November 17, 2020

Zoning Board of Adjustment
Temple Town Office
Delivered by email

Re: Application for Special Exception, Tax Map 2, Lot 17 – Ben’s Pure Maple Products LLC

TEST PIT LOG
DATE: 10-8-2013
SOIL TYPE*: 613A CROGHAN
LOAMY FINE SAND

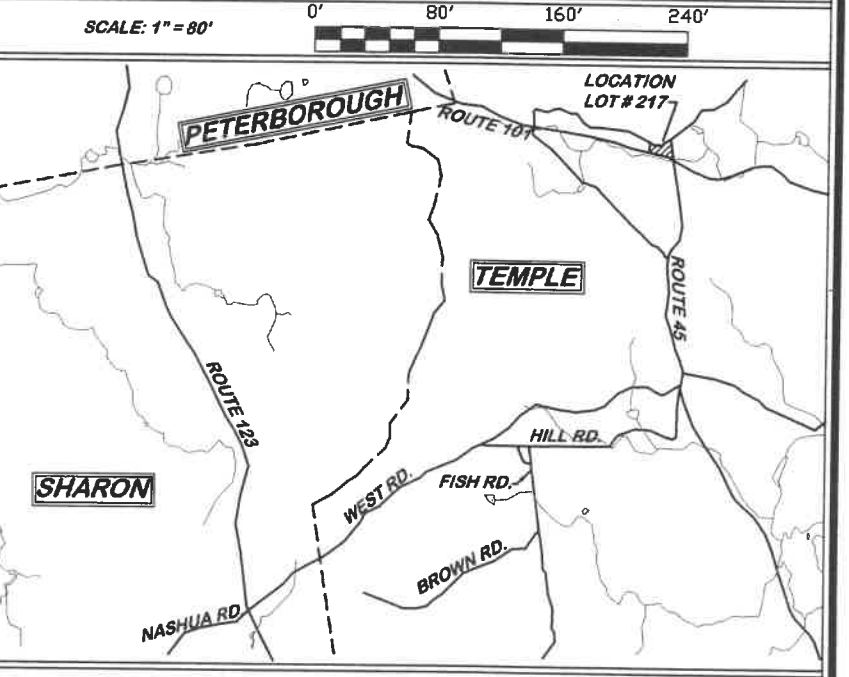
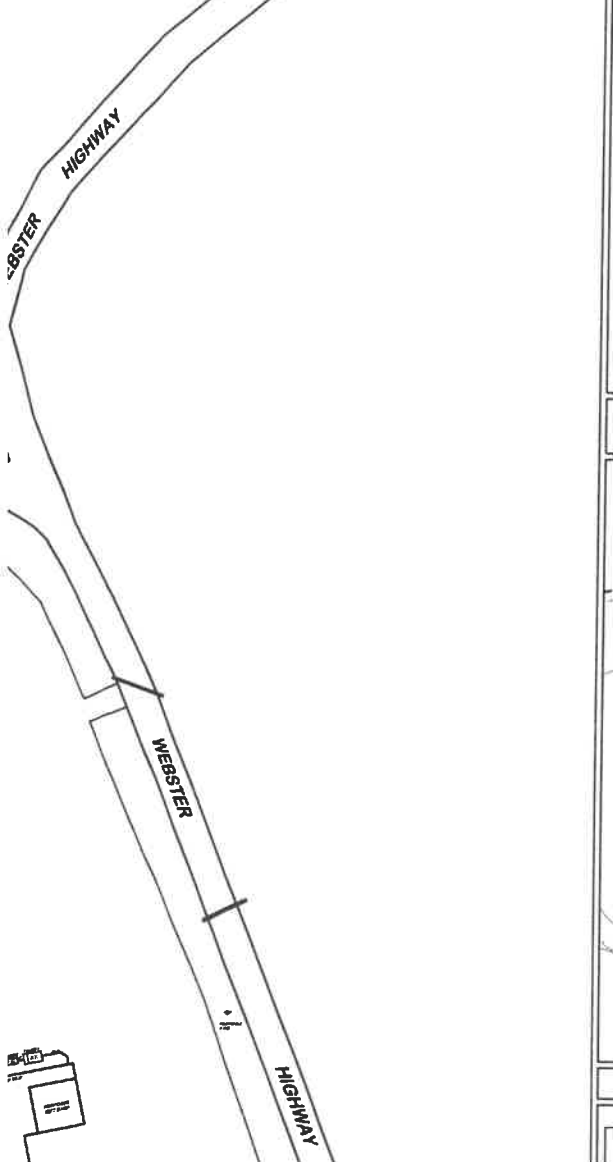
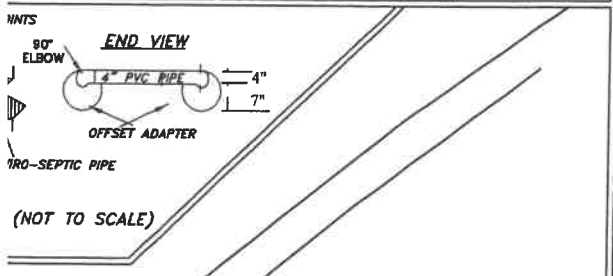
The applicant has described this site as well drained. The historical canal, the test pit data from the existing septic system noting an estimated season high water table at 19" and the raise septic leach field seem contradictory. Attachment #1, existing septic system test pit profile.
